# UNITED STATES PATENT AND TRADEMARK OFFICE

APPLICATION NO.	FILING DATE	FIRST NAMED INVENTOR	ATTORNEY DOCKET NO.	CONFIRMATION NO.
10/799,437	03/12/2004	Jorg-Reinhardt Kropp	16274.9a.1	6223
22913	7590	04/01/2009	EXAMINER	
Workman Nydegger 1000 Eagle Gate Tower 60 East South Temple Salt Lake City, UT 84111			CHIEM, DINH D	
			ART UNIT	PAPER NUMBER
			2883	
			MAIL DATE	DELIVERY MODE
			04/01/2009	PAPER

<b>Office Action Summary</b>	<b>Application No.</b> 10/799,437	<b>Applicant(s)</b> KROPP, JORG-REINHARDT	
	<b>Examiner</b> ERIN D. CHIEM	<b>Art Unit</b> 2883

**DETAILED ACTION**

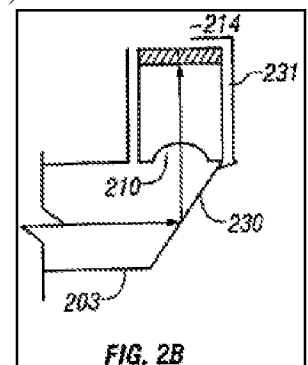
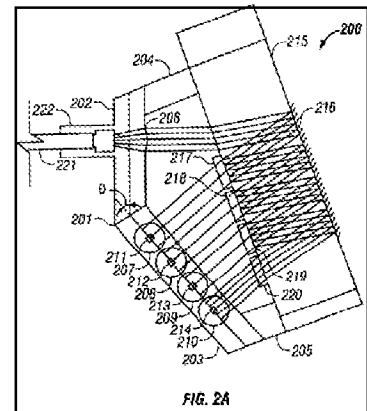
Claims 1-4, 10-13 and 15-26 are rejected under 35 U.S.C. 102(e) as being anticipated by Chen et al.(US 6,870,976 B2). In terms of claim 1, Chen discloses an apparatus for multiplexing and/or demultiplexing optical signals having a plurality of wavelengths, the apparatus comprising:

- a multiplex body having a first and second parallel surfaces between which light is reflected back and forth and coupled in or out in a wavelength-dependent manner (215);
- a first subassembly including a first optoelectronic transducer (214) on a first side of a first substrate and an associated optical system having a first lens (210) in a second side of the first substrate; and
- a second subassembly including a second optoelectronic transducer on a first side of a second substrate and an associated optical system having a second lens in a second side of the second substrate.

Regarding the plurality of subassembly, Fig. 2A shows how the multiple subassemblies are structured on the glass substrate (215).

Regarding claim 2, the parallel pencil beams are shown in Fig. 2A.

Regarding claim 4, the portion that is between element 204 and 205 wherein the angular block is Chen's means for providing an angular orientation of the optical path of each subassembly with respect to the second surface of the multiplex body.

Regarding claims 10 and 12, the apparatus further comprising wavelength selective filters, each wavelength selective filter (215).

Regarding claim 13, the reflection layer is shown as element 216.

a monolithic transparent body (Fig. 2A, '215') having first and second parallel surfaces, each of the first and second surfaces being at least partially reflective (see the zigzag pattern of the light beams);

a first subassembly mounted (211) adjacent to the second surface of the monolithic transparent body and including a first optoelectronic transducer supported by a first side of a first substrate, wherein a first lens (207) is formed in a second side of the first substrate opposite the first side, the first lens defining an associated optical axis aligned at an oblique angle relative to the second surface;

a second subassembly (212) mounted adjacent to the second surface of the monolithic transparent body and including a second optoelectronic transducer supported by a first side of a second substrate, wherein a second lens (208) is formed in a second side of the second substrate opposite the first side~ the second lens defining an associated optical axis aligned at an oblique angle relative to the second surface; and

first and second wavelength-selective filters (217-218) mounted between the second surface and a corresponding one of the first and second subassemblies.

Regarding claim 26, at least one of the optoelectronic transducers emit directly into the substrate (See. Fig. 2A).
